ISO/TC 172/SC 7/WG 2
Spectacle frames

New Japanese comments on N242

Date of document: 2017-09-21

Japanese comments on N242

2) C16 for ISO8624, Proposed change

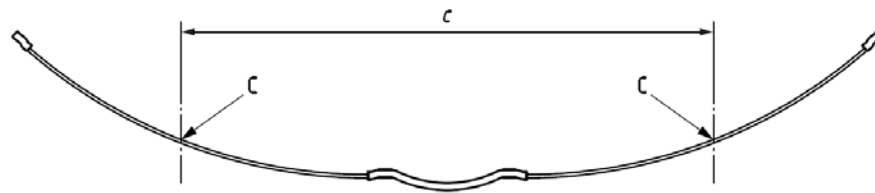
“This is twice the radius, r , (distance) from the boxed centre of the lens shape to the point on the edge furthest from the centre *and an allowance for edging.*”

→“*and an allowance for edging*” should be deleted.

Figure 4 – Measurement of horizontal lens size, vertical lens size and boxed centre distance, distance between lenses and lens plane

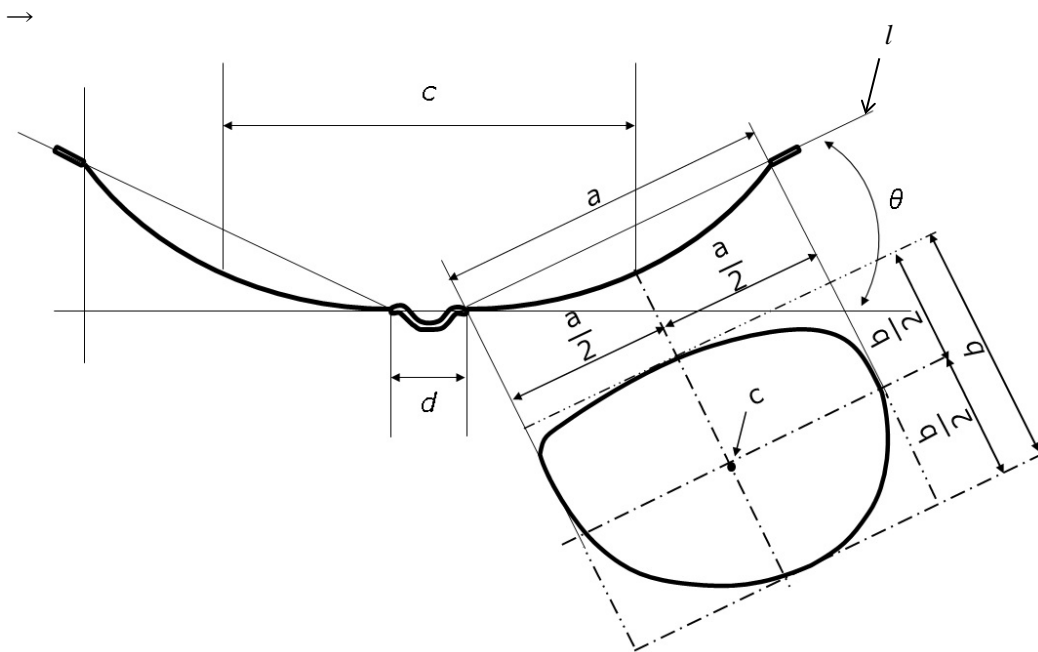
Our proposal is to delete Figure 1 c) and Figure 1 b) in the Annex 1 and to replace Figure 4 to our

new Figure 4.

1. It is difficult to distinguish Figure 1 c) from Figure 1.
2. The caption in Figure 1 for Option 1) reads “this figure applies to frames with insignificant face form angle”. But, there is no rule to distinguish “insignificant” from “significant”.
3. We discussed the lens plane including a Japanese expert from edging machine manufacture. We agreed that the lens plane should be based on the bottom of lens groove.
